Potential PTO Hose Damage

Product: Groundsmaster® 4000

May 18, 2012

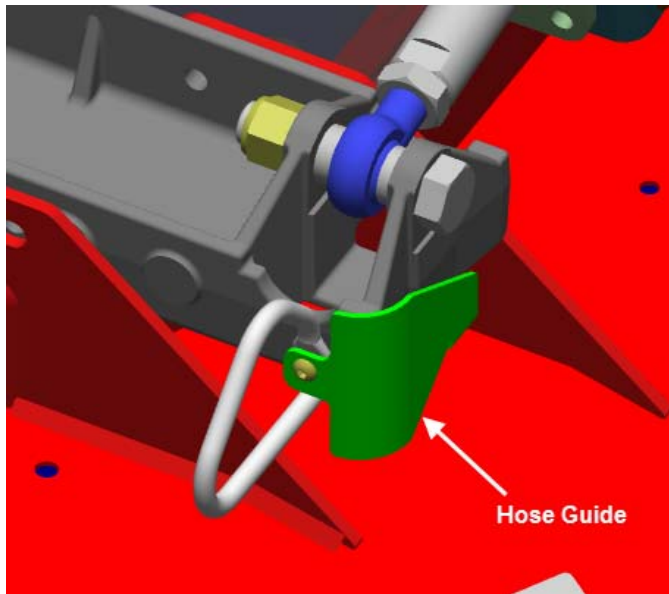
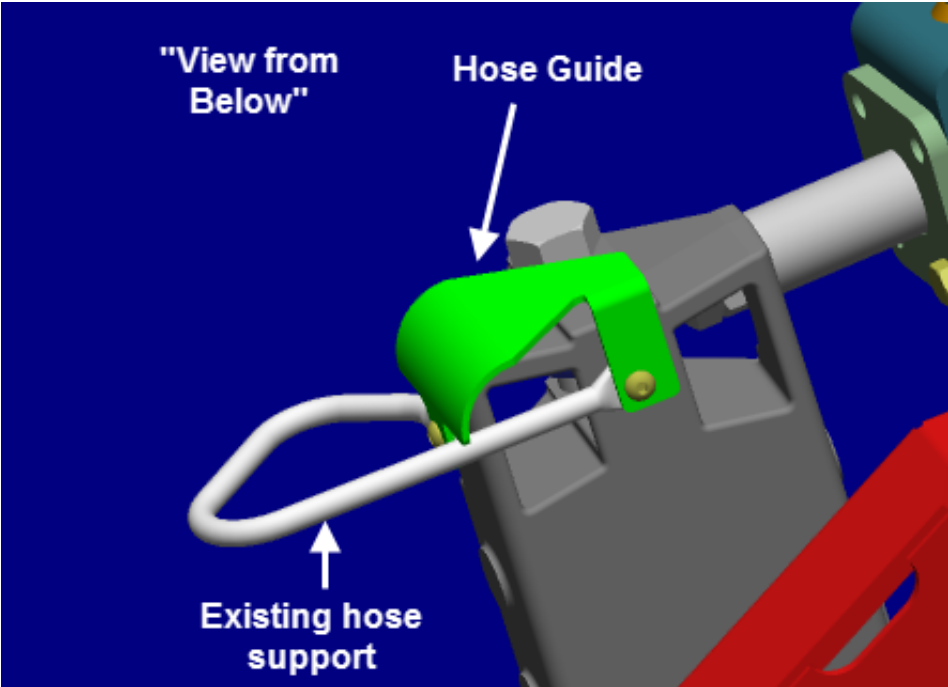
Wing deck PTO hoses may rub on wing deck mount.

Inspect PTO hoses for signs of rubbing on the deck mount casting, and install Hose Guides (120-0480-03 RH and 120-0481-03 LH) to isolate the hoses from the wing deck casting.
